ADDENDUM NO.: 1.0

DATE OF ADDENDUM: October 16, 2014

**Founders Hall Renovations for Allied Health and Nursing
Naugatuck Valley Community College, Waterbury, Connecticut
BI – CTC – 442 – CMR**

ADA PANEL SIGNS -

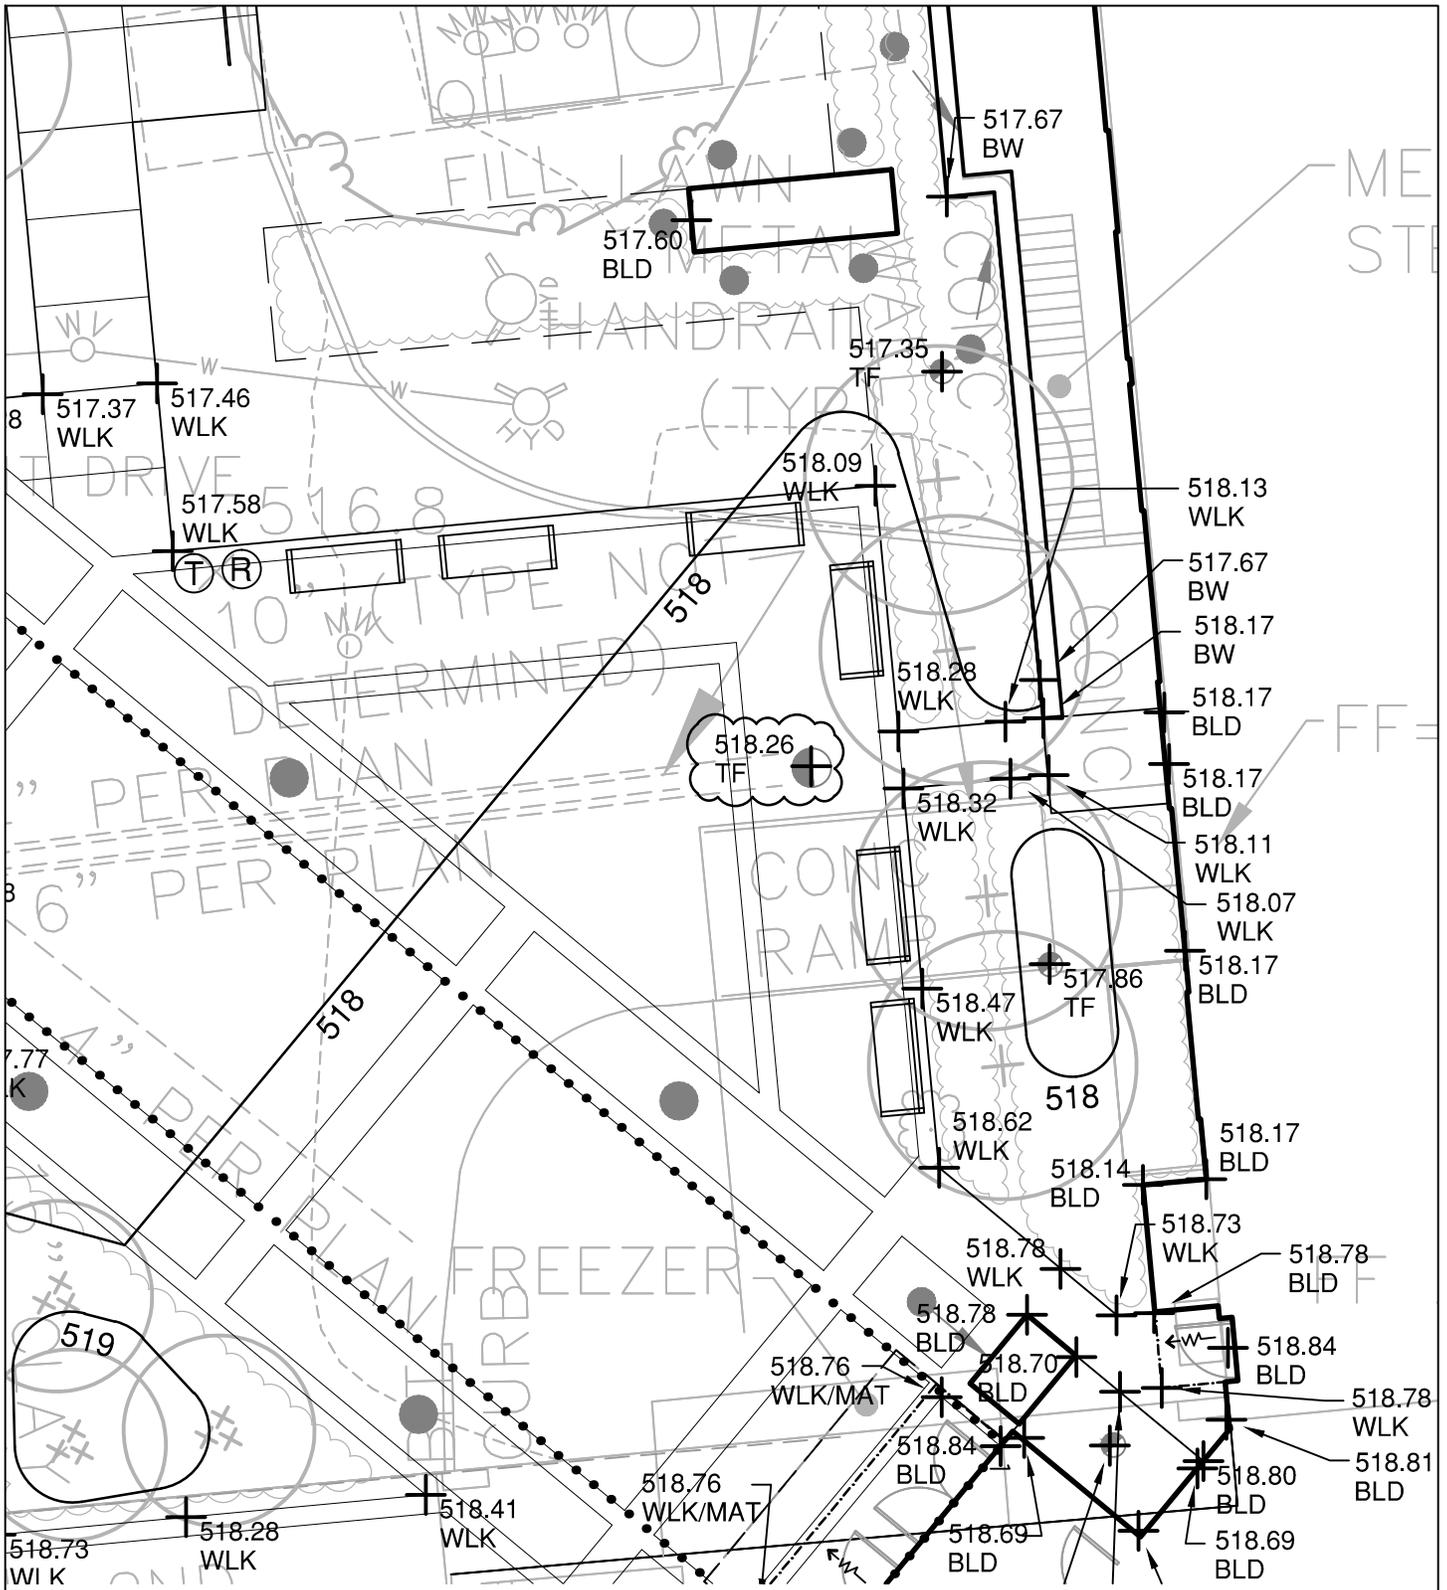
INFO.1 – INFORMATION SHEET: At Mounting Heights **ADD** ADA panel signage as shown on attached sketch AD1-SK-INFO.1.

SKETCH NO.
 AD1-SK-L2.3-1

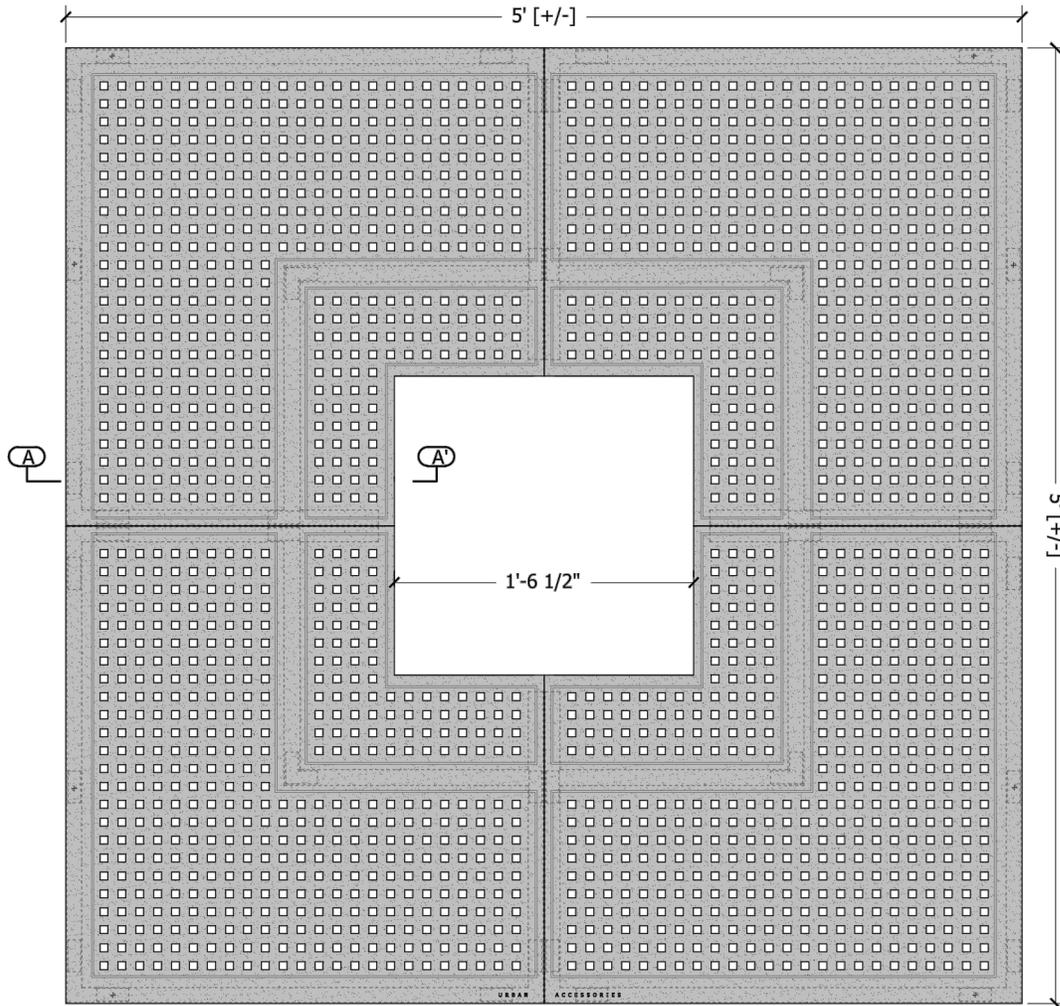
DRAWING L2.3 – SITE GRADING ENLARGEMENT: At detail 1, **REVISE** manhole top of frame elevation as indicated in revision cloud on attached sketch AD1-SK-L2.3-1.

SKETCH TITLE
 TREE GRATE REVISION

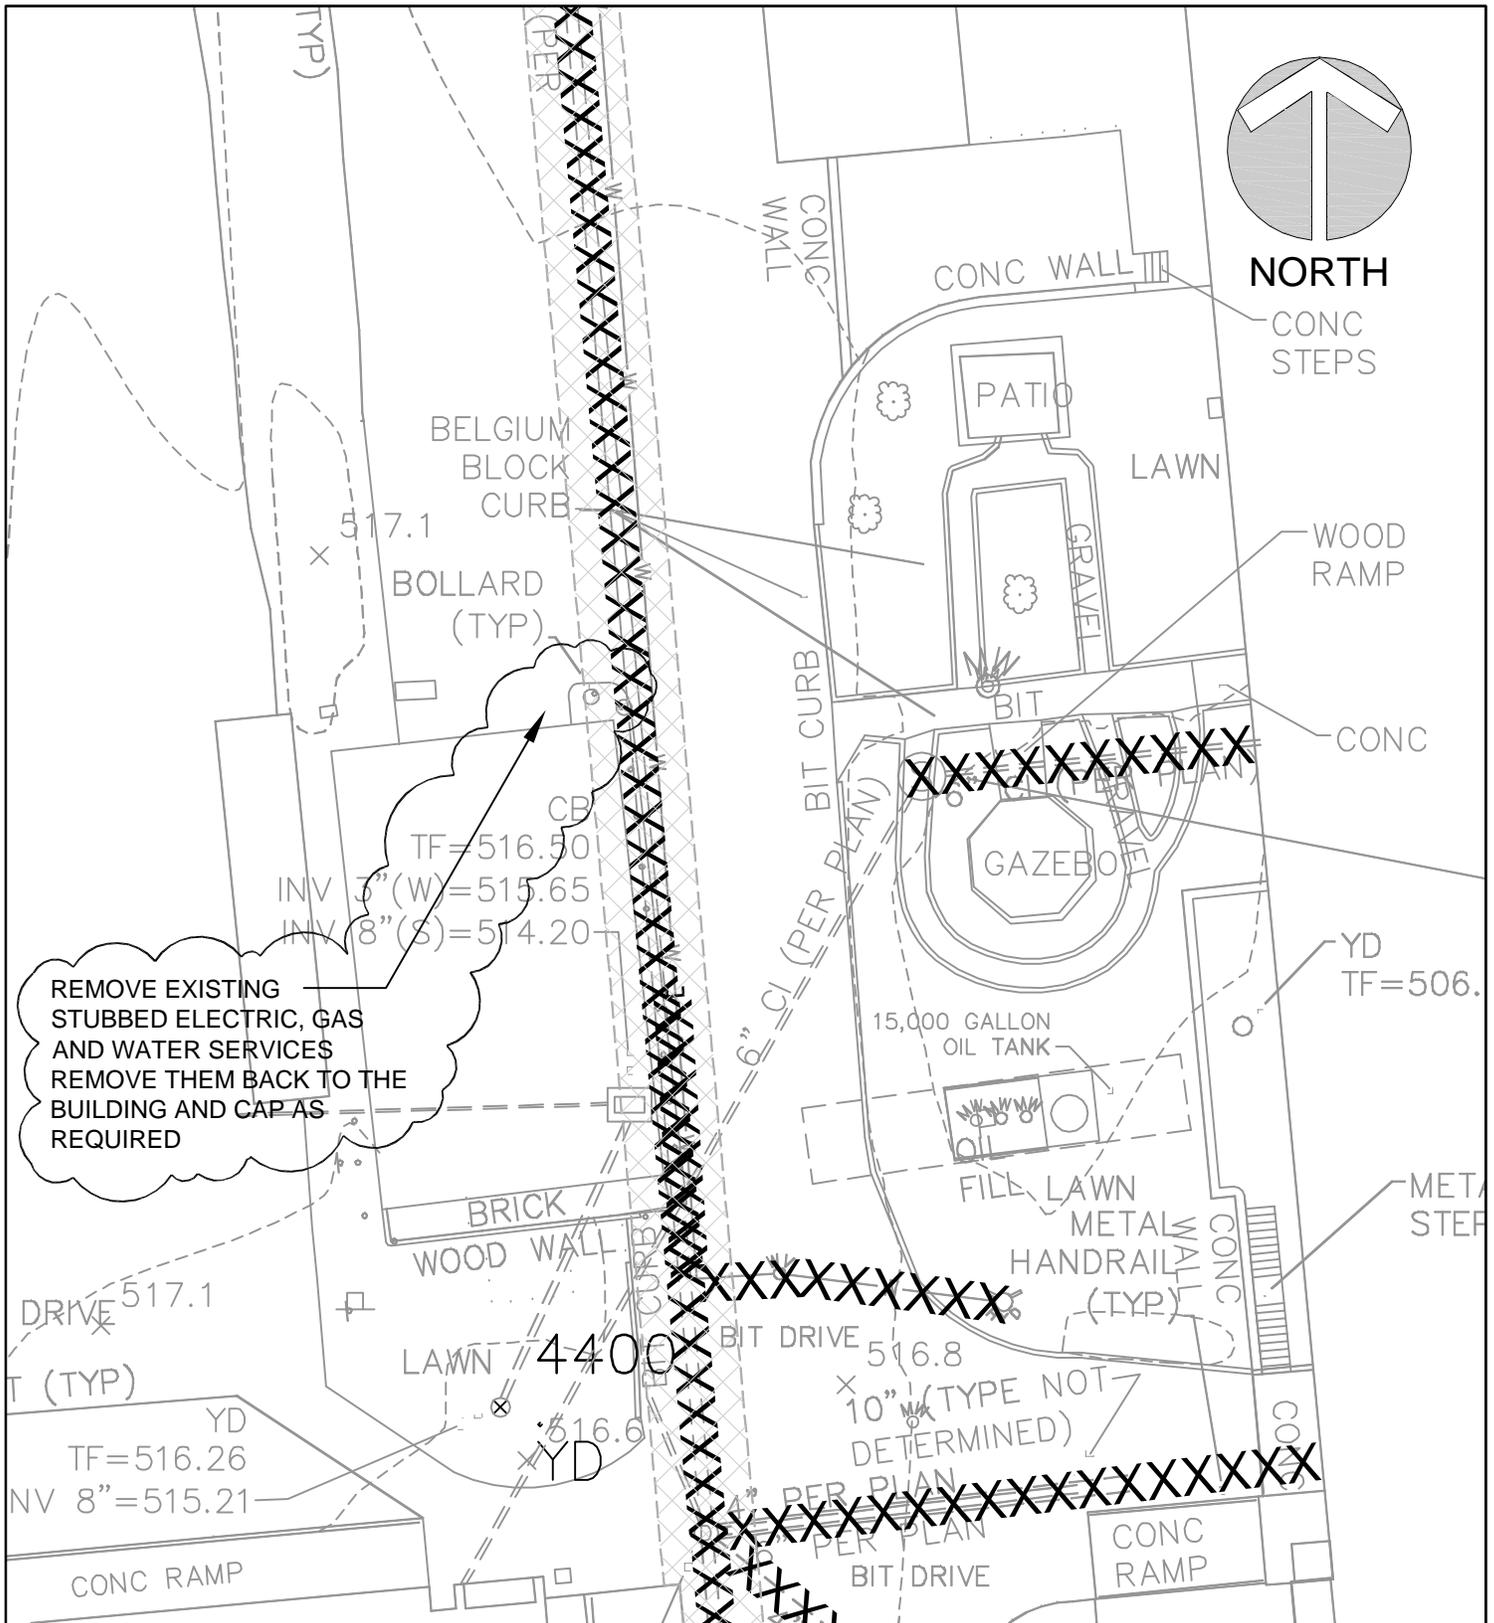
DRAWING L3.5 – SITE DETAILS: **DELETE** detail 5 in its entirety, and **REPLACE** with revised detail as shown on attached sketch AD1-SK-L3.5-1.

SKETCH TITLE
ROOF PLAN AT ELEVATOR

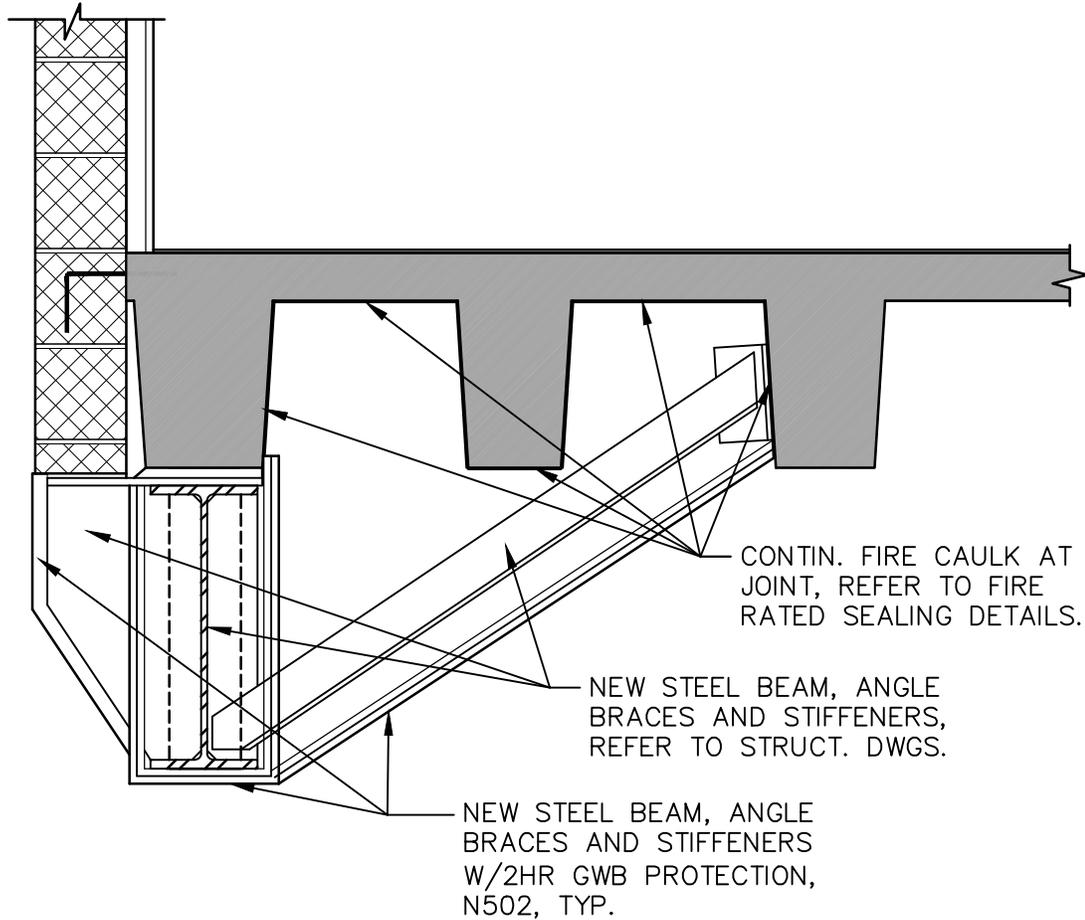
- j. **REVISE** raised elevator override roof per attached sketch AD1-SK-A1.4B.

DETAIL THRU FLOOR FRAMING

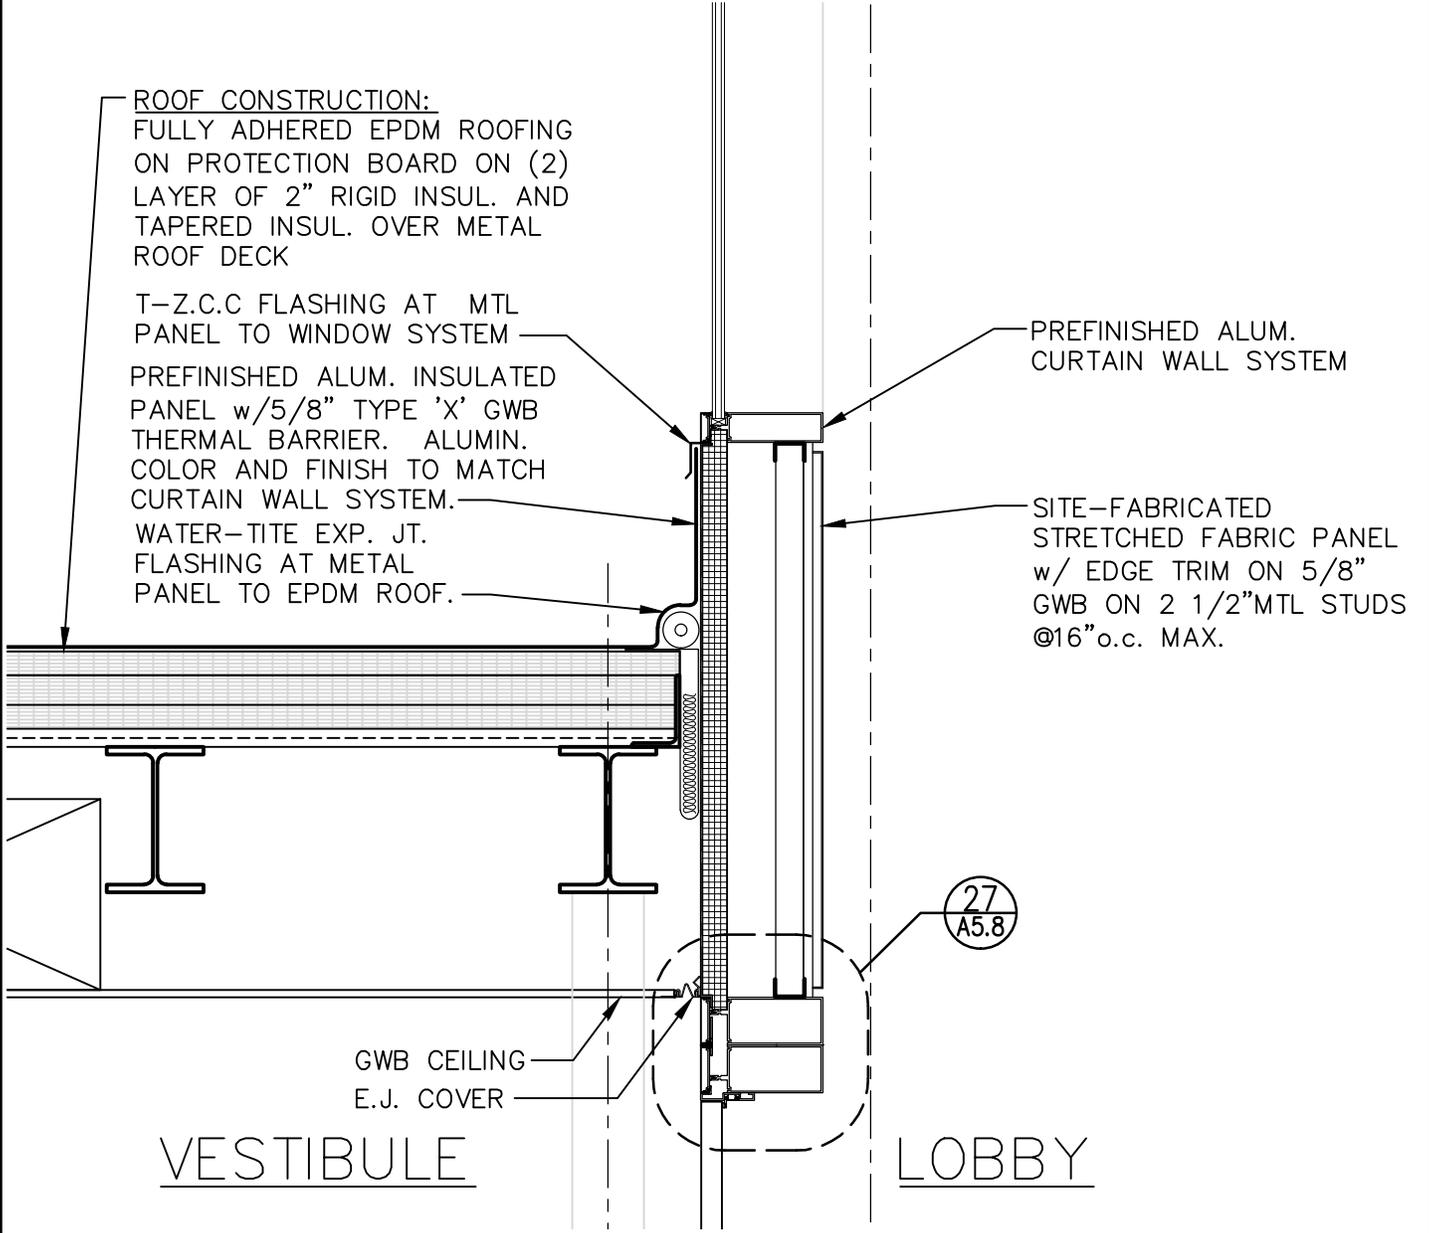
- a. At detail 20A **ADD** section marker 20B/A2.10 perpendicular to mechanical chase shown at first floor framing.
- b. **ADD** detail 20B as shown on attached sketch AD1-SK-A2.10.
